DEVELOPMENT REVIEW BOARD REPORT

CASE NUMBER/ PROJECT NAME	13-DR-2005 Desert Park Community Center		
LOCATION	98th Street And Union Hills Drive		
REQUEST	Request approval for a site plan and elevations for a new community and recreational facility at DC Ranch.		
OWNER	DC Ranch LLC 480-367-7000	ENGINEER	Wood, Patel & Associates Inc. 480-834-3300
ARCHITECT/ DESIGNER	SHJ Studio 602-248-4912	APPLICANT/ COORDINATOR	Shelly McTee Biskind Hunt & Taylor 602-955-2328
BACKGROUND	<p>Zoning.</p> <p>This property is located on the south side of Union Hills Drive, between the Reata Wash and Thompson Peak Parkway. The R1-7 PCD District allows community centers upon approval of a conditional use permit, which was approved by the City Council in February 2005.</p> <p>Context.</p> <p>This 3.5-acre property is located at the south side of the DC Ranch Master Planned Community and is part of DC Ranch's Town Center study area. This property is bounded by Union Hills Drive and future single-family homes to the north, future multi-family condominiums to the east, future single-family homes to the south, and the Reata wash and single-family homes to the west. The property has gentle slopes to the southwest

ELEVATIONS

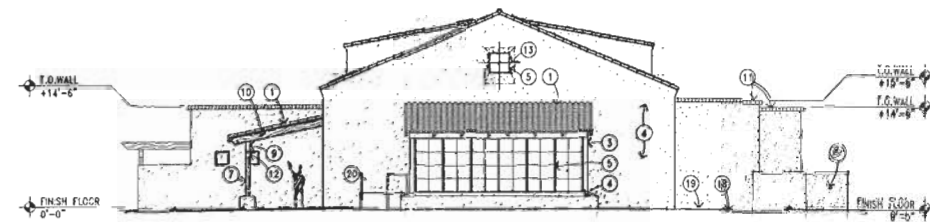
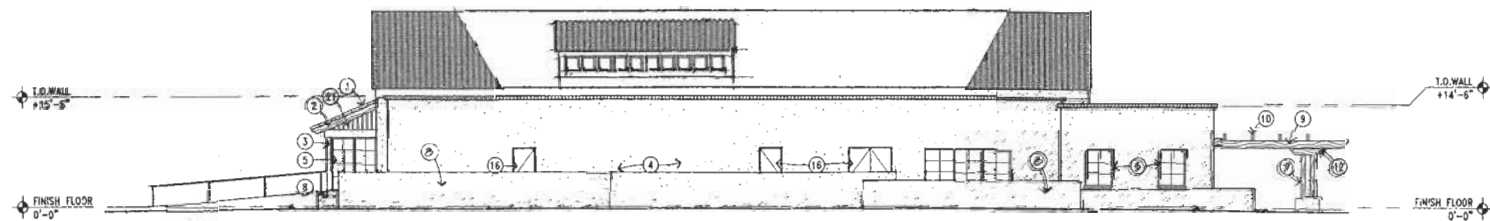
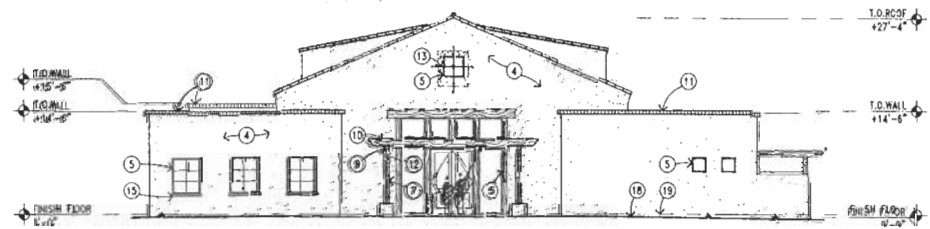
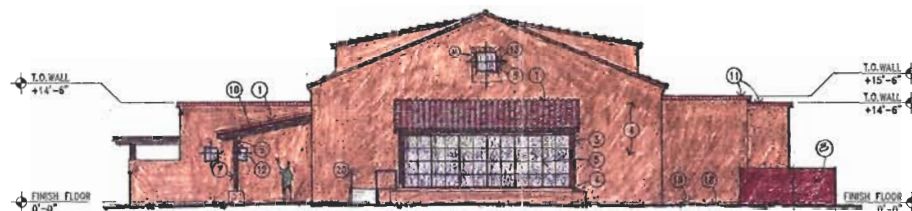
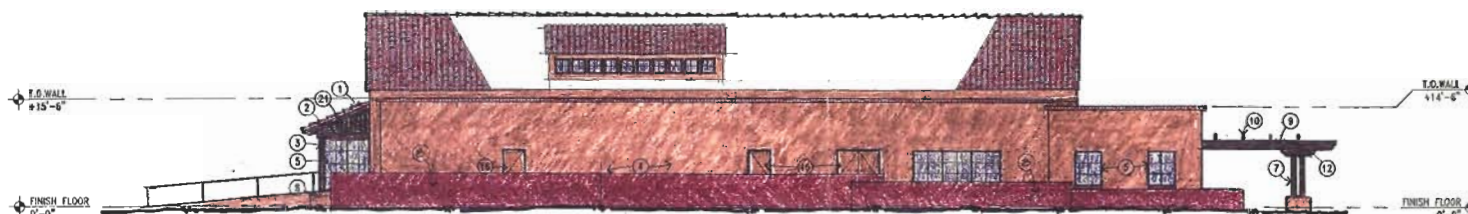
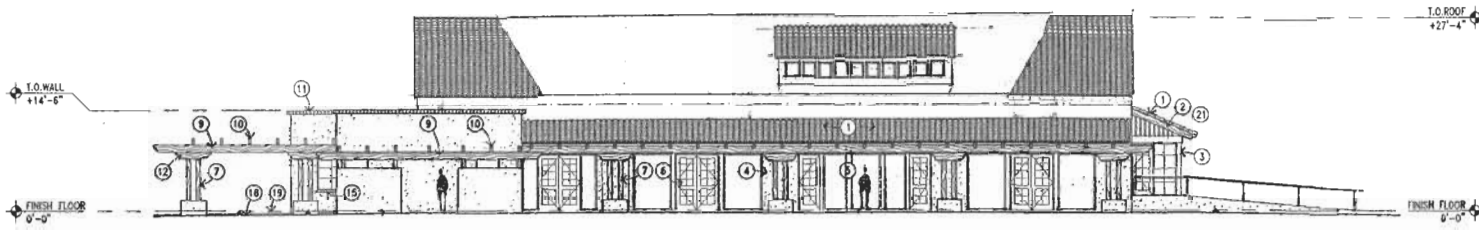
- a. Architectural elements, including dimensions, materials, form, color, and texture, shall be constructed to be consistent with the building elevations submitted by SHJ Studio with a date provided on the plan by city staff of 2/9/05.
